Product/Process Change Notice (PCN)

PCN_IndPMCI_74479288XXX_datasheet_correction_19052017

Product Affected: WE-PMCI 74479288xxx

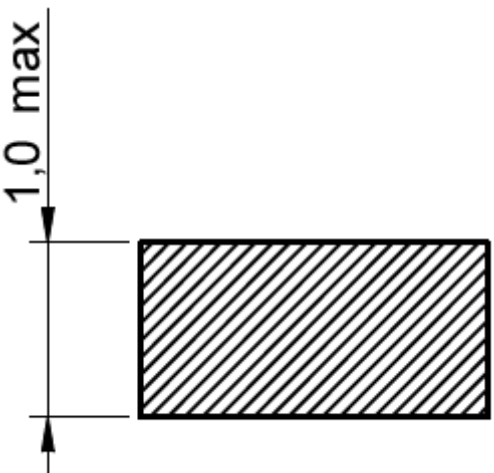
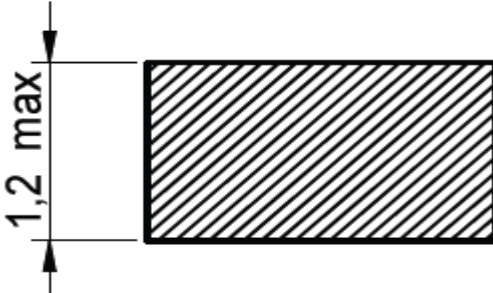
Because of a database mismatch, Würth Elektronik will change the maximum height in the datasheet.

The height of the component in the datasheet will be changed as described below.

- 74479288147
- 74479288210
- 74479288215
- 74479288222

Before	After
 <p>1,0 max</p>	 <p>1,2 max</p>
RELIABILITY / QUALIFICATION SUMMARY: --/--	
DATA SHEET CHANGE: <input checked="" type="checkbox"/> Yes <input type="checkbox"/> No
